ZBA MEETING PACKET

06/13/23

ZBA TABLE OF CONTENTS FOR PACKET – 06/13/2023

V. SURFSIDE CROSSING FINAL SITE PLAN/ENGINEERING REVIEW AND REVIEW OF CONDITIONS

Date: FEBRUARY 15, 2018 | Drawn: RMM/ERC/BEI | Checked: DFB/AMG | Sheet: 4 of 11

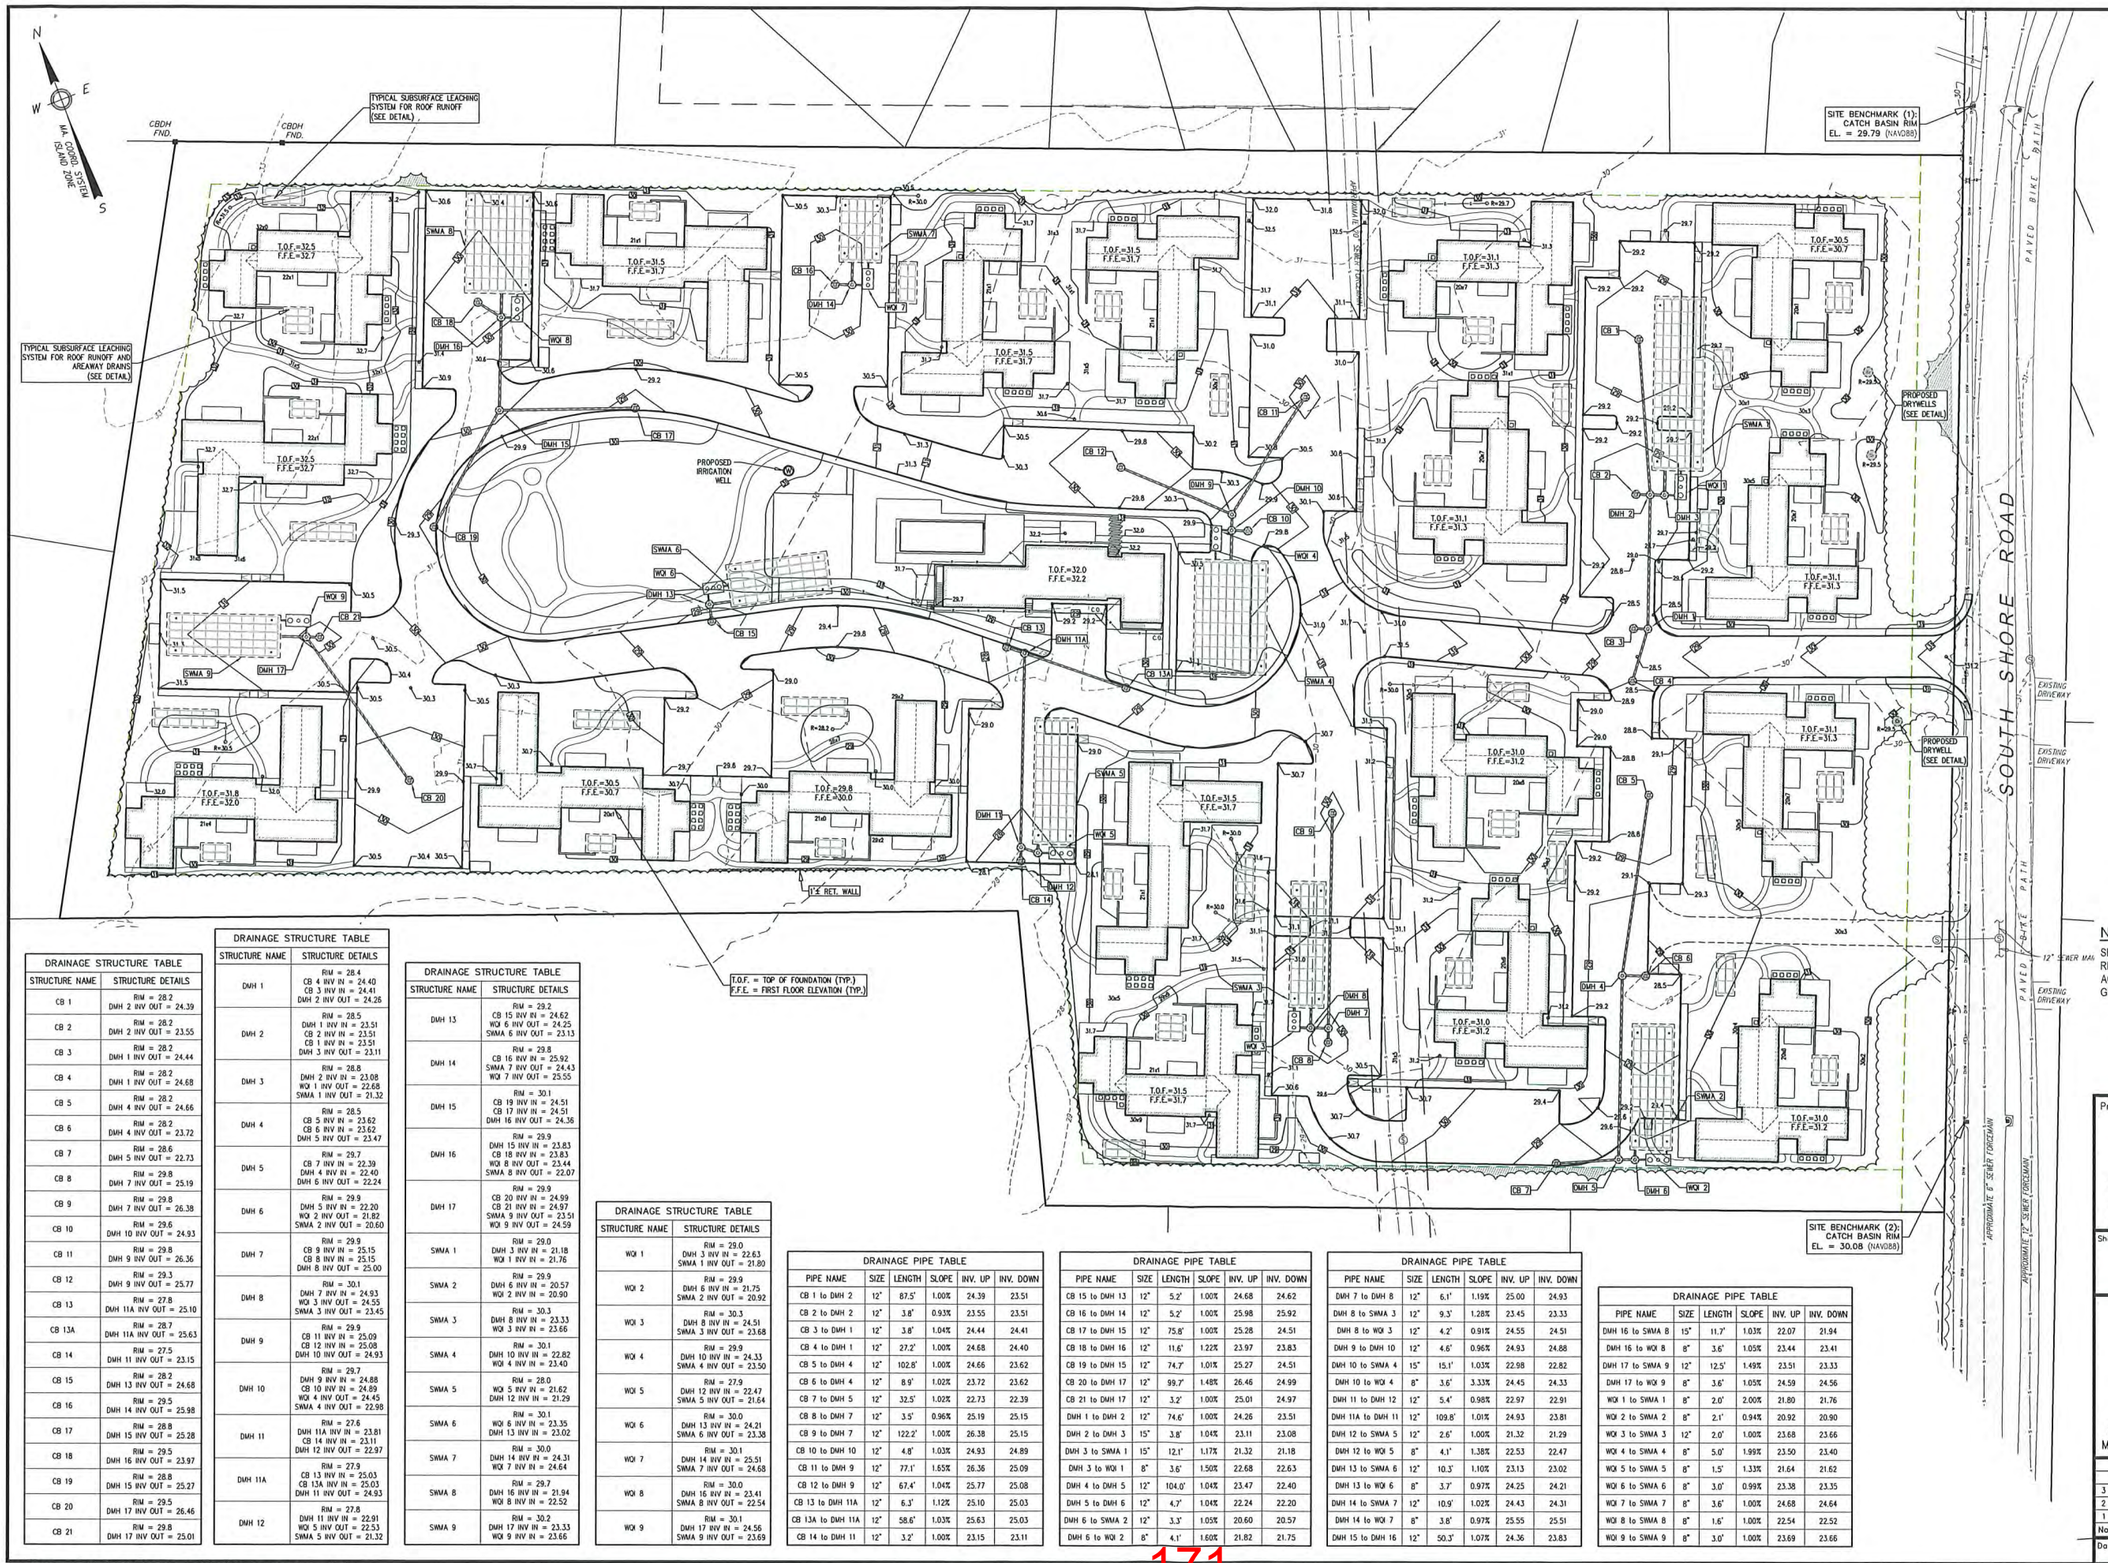
p. All zoning lines have been identified on the final plan for reference purposes.
The zoning district and setbacks are indicated in a table on Sheet 4. Setback lines associated with the District are not on the plans.
The Response indicates that "District setback lines have not been included to avoid confusion.
